MCPB  
Item No.  
Date: 11-30-17

## Leisure World Administration Building and Clubhouse I, Site Plan No. 820170120

- Request for approval to replace an existing Administration Building with a new 20,555-square-foot building, a 1,315-square-foot addition to the Clubhouse, a new 71-space parking lot, and related landscape, hardscape and stormwater management improvements, upgrades to an existing parking lot, and various pedestrian and vehicular circulation improvements;
- Location: Northeast corner of Rossmoor Blvd., and N. Leisure World Blvd.; 1994 *Aspen Hill Master Plan*;
- Size: 11.60 acres;
- Zone: Planned Retirement Community (PRC);
- Applicant: Leisure World Community Corp.;
- Accepted: June 26, 2017.

Figure 6: Plaza at the main entrance to the new Administration Building

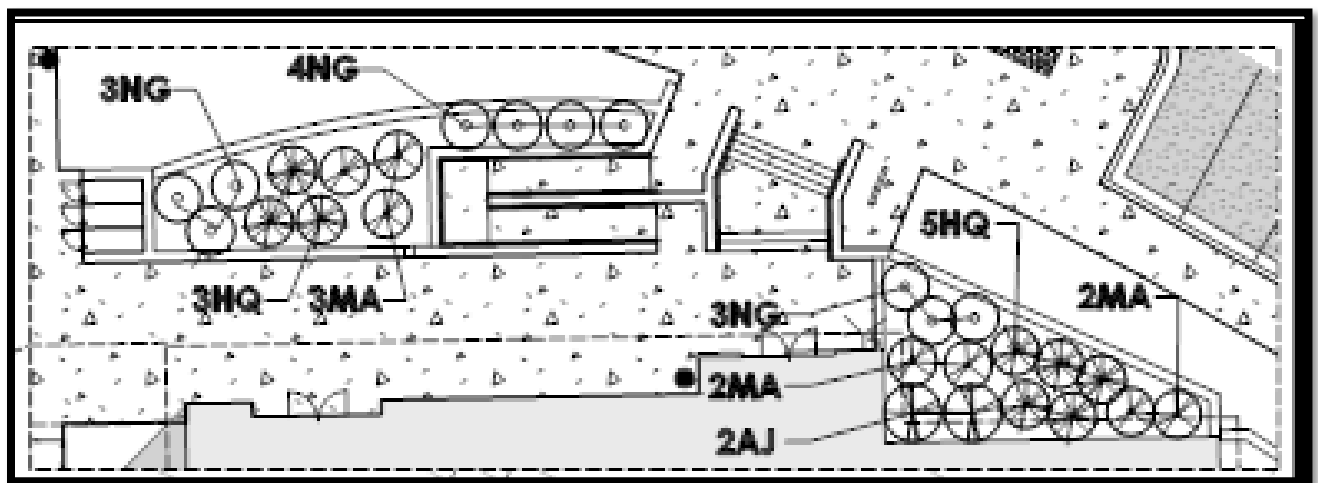
- d) Revise the layout and design of the Administration Building's entrance plaza to be substantially similar to the sketches prepared by Staff as part of the last review comments or, provide a Staff-approved alternative.
